BIDDING AND CONTRACT DOCUMENTS
ADDENDUM NUMBER ONE
STATE PROJECT NO. 23-013A-1

DATE: JUNE 18, 2024

CAMERON MEMORIAL AIRPORT

SUBJECT: ADDENDUM NUMBER ONE TO THE BIDDING DOCUMENTS FOR:
RECONSTRUCT RUNWAY 17-35

SHEET TITLE
AIRPORT SITE PLAN

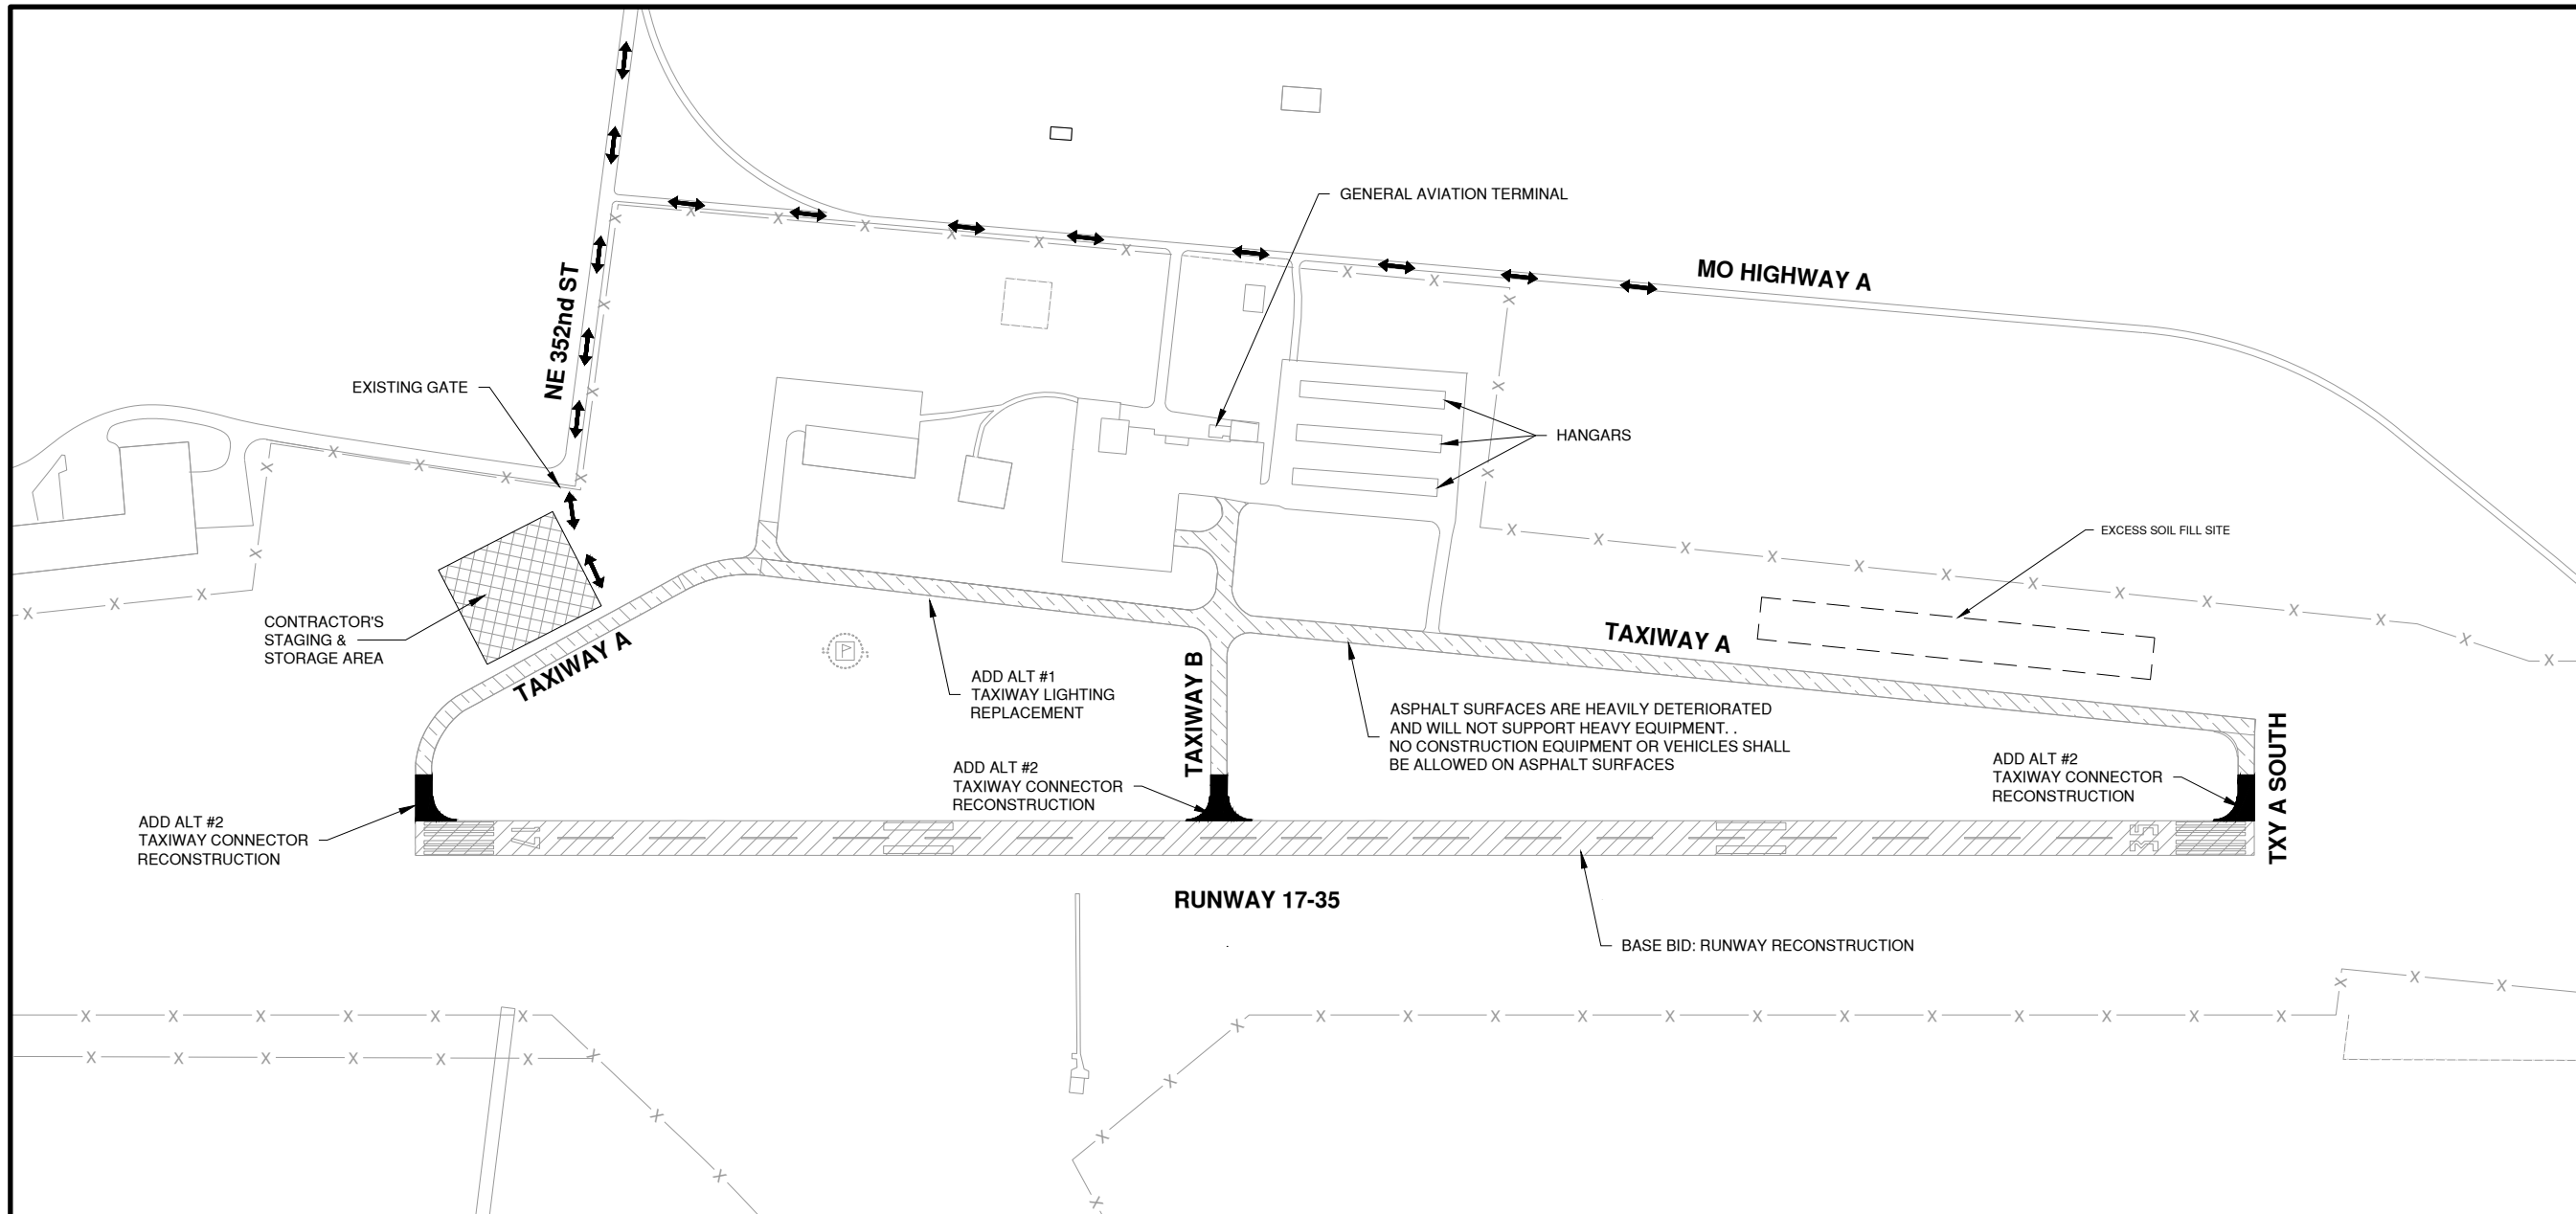
REPLACE Sheet 3 with Sheet 3, Revision 1.

1. The P-152 method of measurement and basis of payment are being switched from unclassified excavation to embankment in place. The earthwork table on Sheet 3 of 79 shows the volume of the pavement removal as cut and the volume of shoulder adjustment as fill. This table has been updated in the revised plan sheet to show the total cut and fill volumes from the shoulder adjustment as calculated from the cross sections using the average end area method with no adjustment for shrinkage.
2. The Item P-501 testing and acceptance requirements are being changed as part of Addendum No. 1 from flexural testing to compressive testing.
3. The L-853 retroreflective markers are to be 24” tall to match the proposed lights.

SHEET TITLE
EXISTING TYPICAL SECTIONS

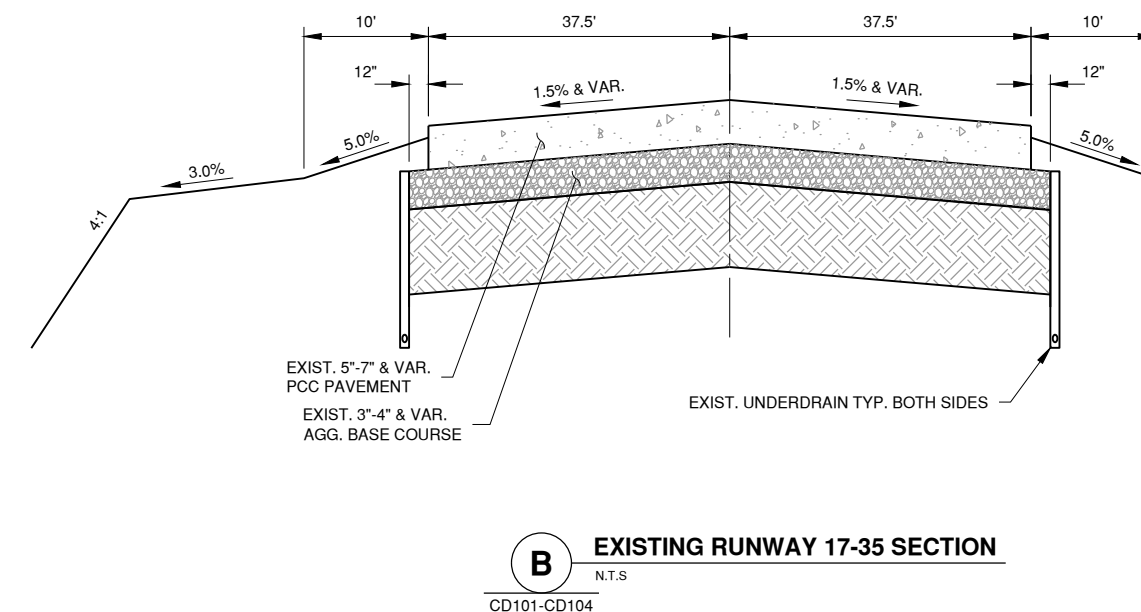
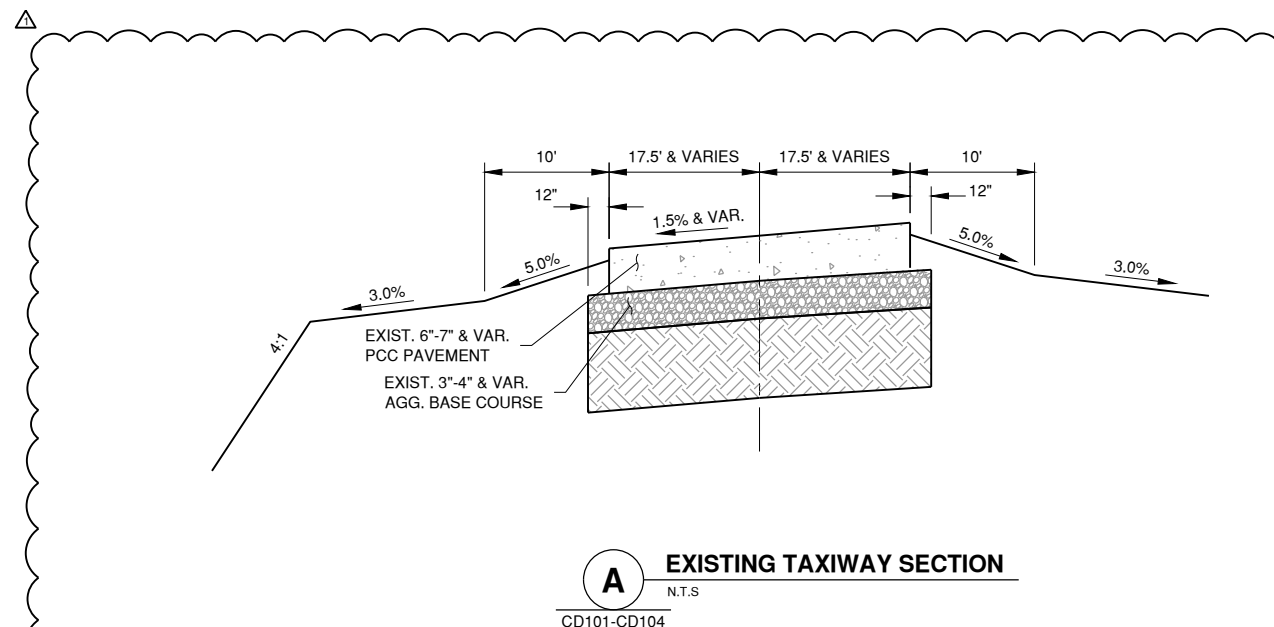
REPLACE Sheet 11 with Sheet 11, Revision 1.
